From: Joshua Hill
To: Danny Mapili - WPD-C
Cc: Terry Lamb Sr.; Todd Williams; Patrick J. Murray; Kaan Dilber; Andrea Mango; Edwin Lopacki - WPIB
Subject: RE: FERC Swing: Status of Design Review
Date: Friday, July 15, 2016 6:07:19 PM
Attachments: image001.png

Good morning Josh,
I would like to check the status of the Design Review for the 100%CD's FERC Swing.

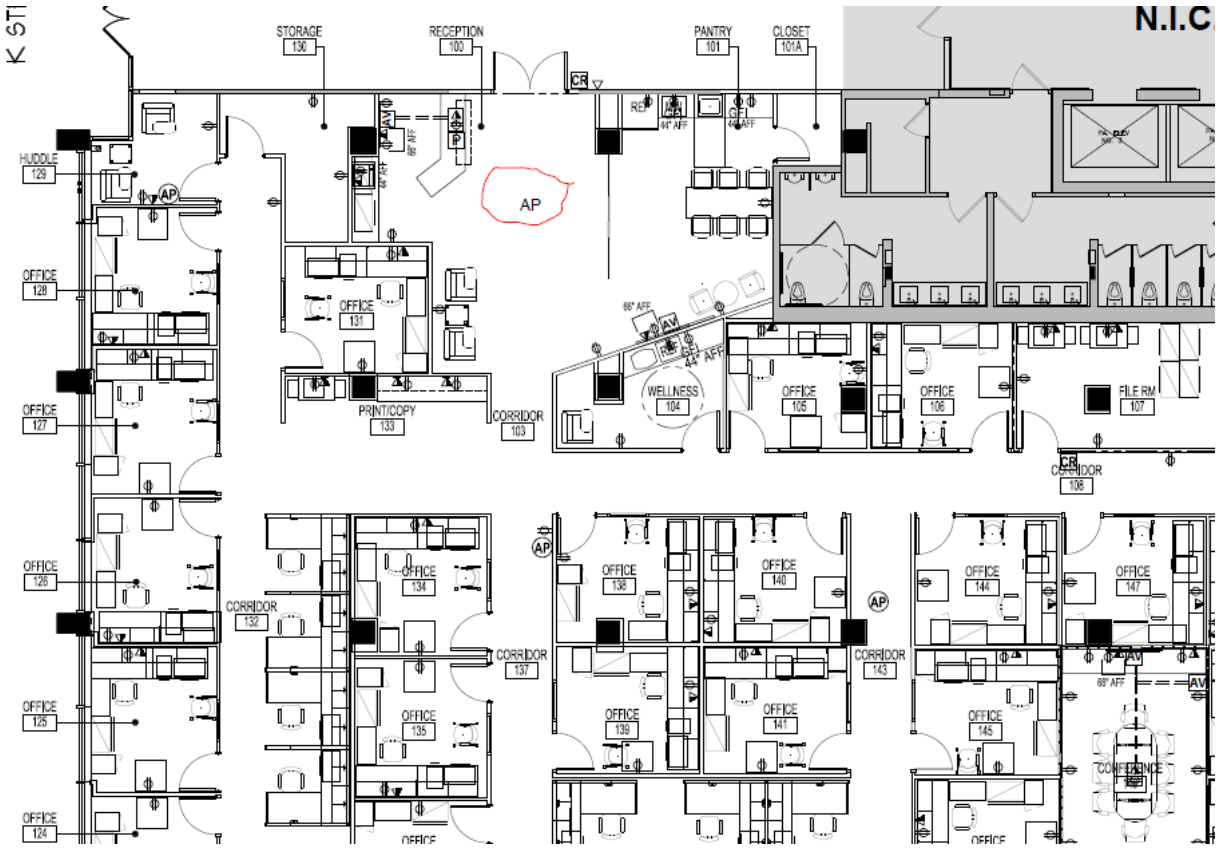
On A301, we may need an additional wireless access point located in the vicinity of the entrance to the suite (see drawing below).
